**COLLEEN CAROL CASEY  
MATERIALS LICENSING BRANCH  
UNITED STATES NUCLEAR REGULATORY COMMISSION**

**CONVERSATION RECORD**

License No.: 21-01190-05

Control No.: 314270

FACILITY DIAGRAM

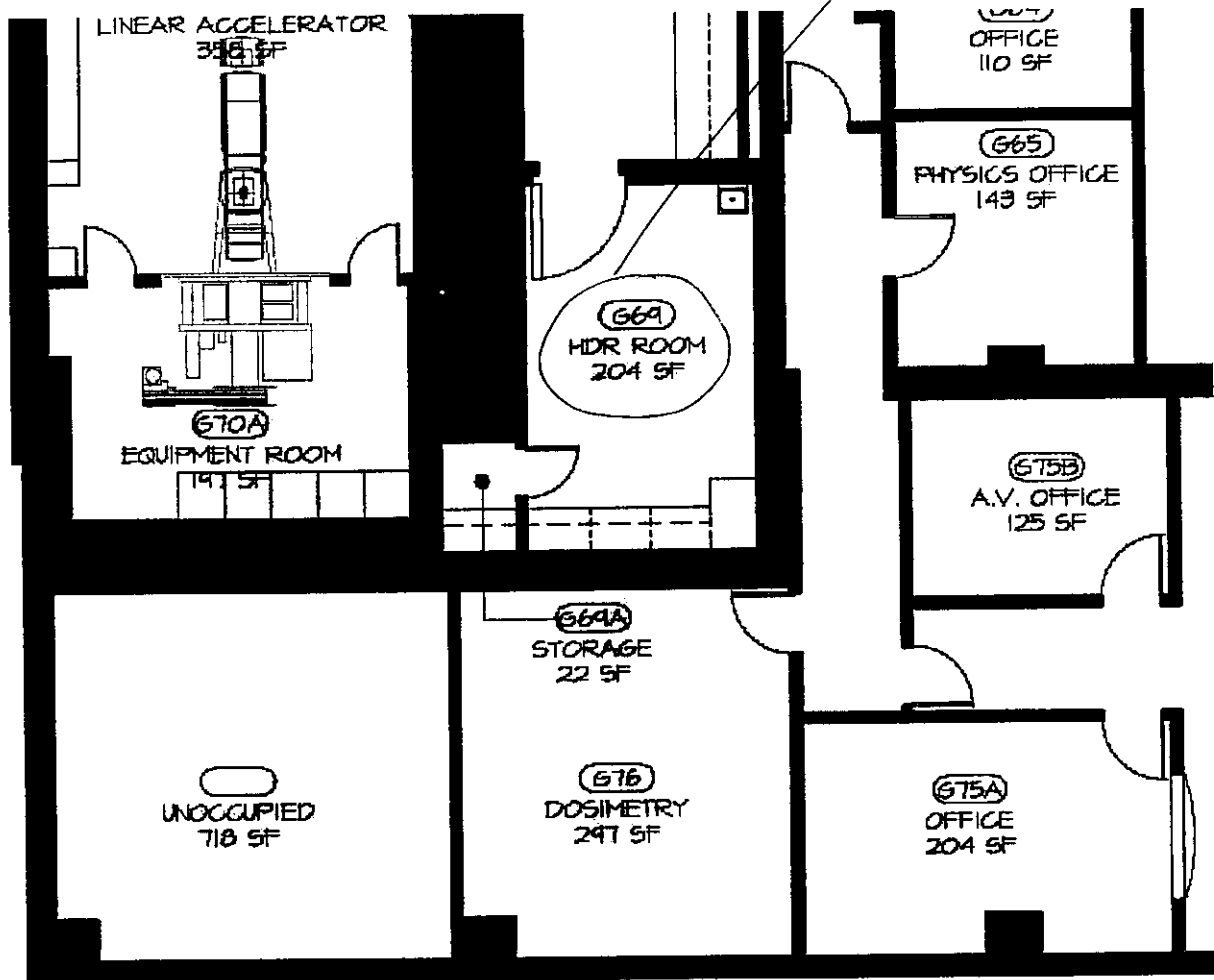
Item 8.15, Item 9 of your renewal application dated March 10, 2005, shows a facility diagram, including a room labelled "HDR room," marked G69. Your license does not authorize a HDR device. **Please explain this room marking.**

Precaution  
notation on  
Diagram
